17715 Meeting House Road, Sandy Spring  
PRELIMINARY CONSULTATION  
Sandy Spring Historic District

**MONTGOMERY COUNTY HISTORIC PRESERVATION COMMISSION**  
**STAFF REPORT**

<b>Address:</b>	17715 Meetinghouse Road, Sandy Spring	<b>Meeting Date:</b>	4/28/2010
<b>Resource:</b>	Outstanding Resource Sandy Spring Historic District	<b>Report Date:</b>	4/21/2010
<b>Applicant:</b>	Sandy Spring Monthly Meeting (Miche Booz, Architect)	<b>Public Notice:</b>	4/14/2010
<b>Review:</b>	Preliminary Consultation	<b>Tax Credit:</b>	Partial
<b>Case Number:</b>	N/A	<b>Staff:</b>	Josh Silver
<b>PROPOSAL:</b>	Relocation of building and alterations to building

1 PROPOSED WEST ELEVATION  
 A4 SCALE: 1/8" = 1'-0"

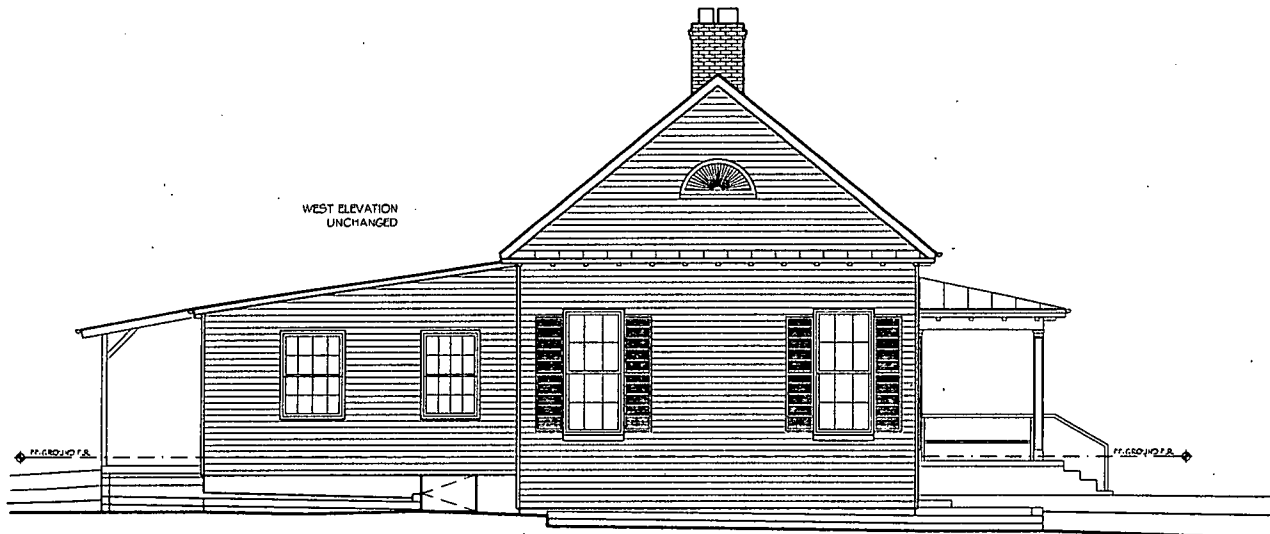
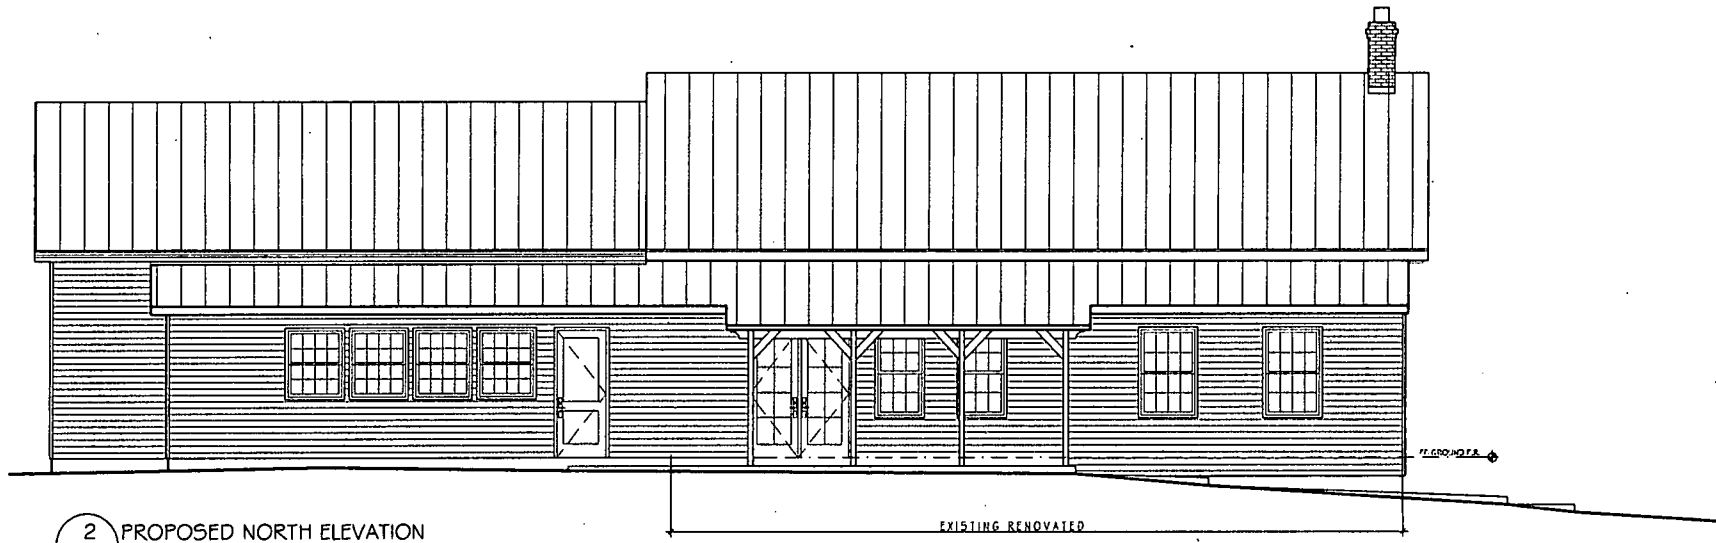
23 MR. RODRIGUEZ: I have a question. Can you  
24 explain a little bit the treatment of the windows in the  
25 kitchen? It seems to be a series of very close windows,

9 I think it's a great project. My only concerns  
10 really are those windows on the kitchen. I feel like there  
11 is a little bit from the -- be careful, it comes a little  
12 bit too close to a more modern gesture that the project is  
13 not following anywhere else. So I would recommend that you  
14 look at that and see how those windows come closer to the  
15 rest of the volume, and that would be the only comment I  
16 would make.

1 PROPOSED EAST ELEVATION  
A3 SCALE: 1/8"=1'-0"

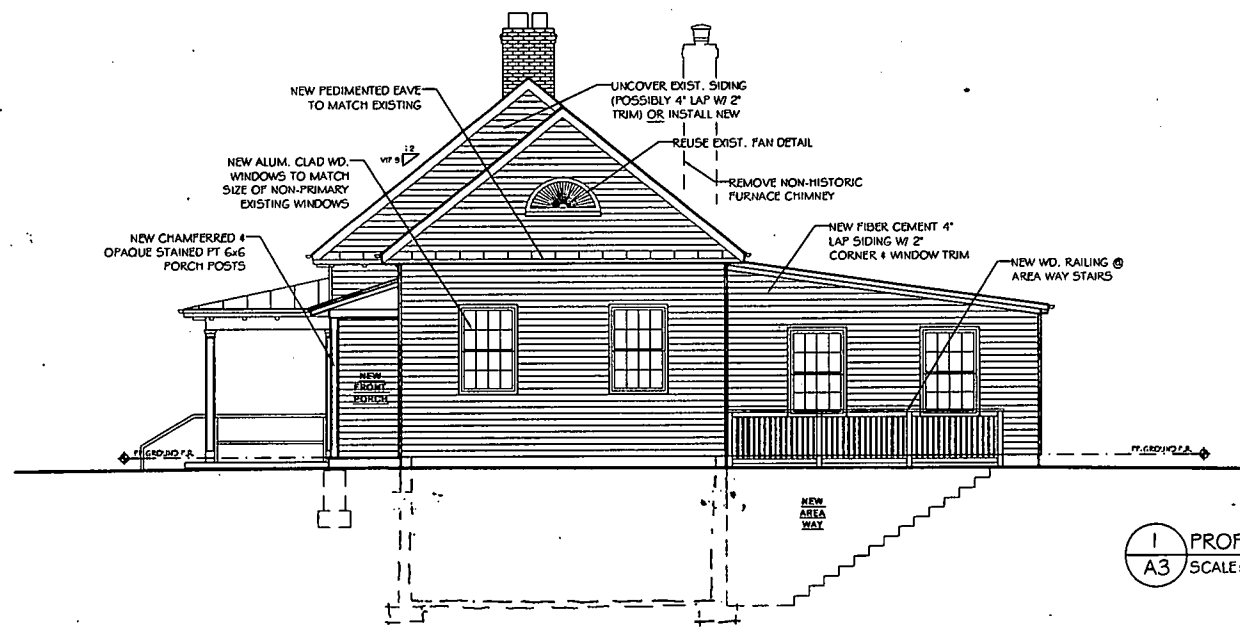
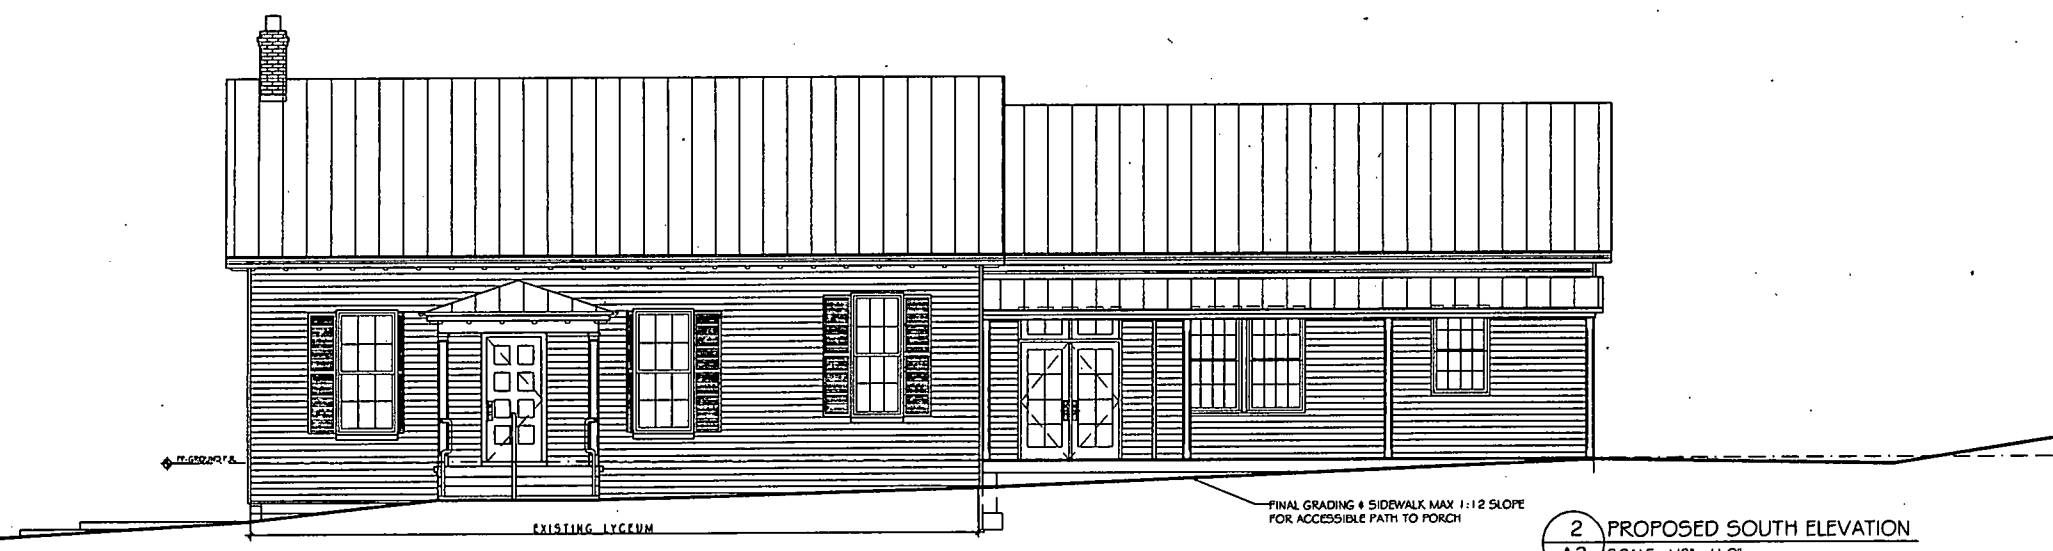
24           MR. KIRWAN: On the proposed east elevation, the  
25 addition, the, I guess the north plane of the roof of the

8 MR. KIRWAN: And the east elevation shows it  
9 being in the same plane as the lyceum roof. On the rear  
10 elevation, or the north elevation, proposed north  
11 elevation, there seems to be some sort of break there, or  
12 something. Is that just a --

20 I think the only thing that sort of my lead in  
21 question was about, breaking the plane of those two roofs.  
22 I think given the outstanding resource category that the  
23 lyceum is in, I think it would be appropriate, and also  
24 possibly help with the new versus old roof juxtaposition to  
25 have a -- some offset between the roof of the addition with

19 MR. BOOZ: I think that the -- I see the line.  
20 It probably represents a material change, since one roof is  
21 going to be new. And that's one of the points of  
22 discussion. And I recognize the, how that might be an  
23 awkward situation if it were a pre-painted roof butting up  
24 to a turned metal roof, a painted turned metal roof, which  
25 if there were that separation.
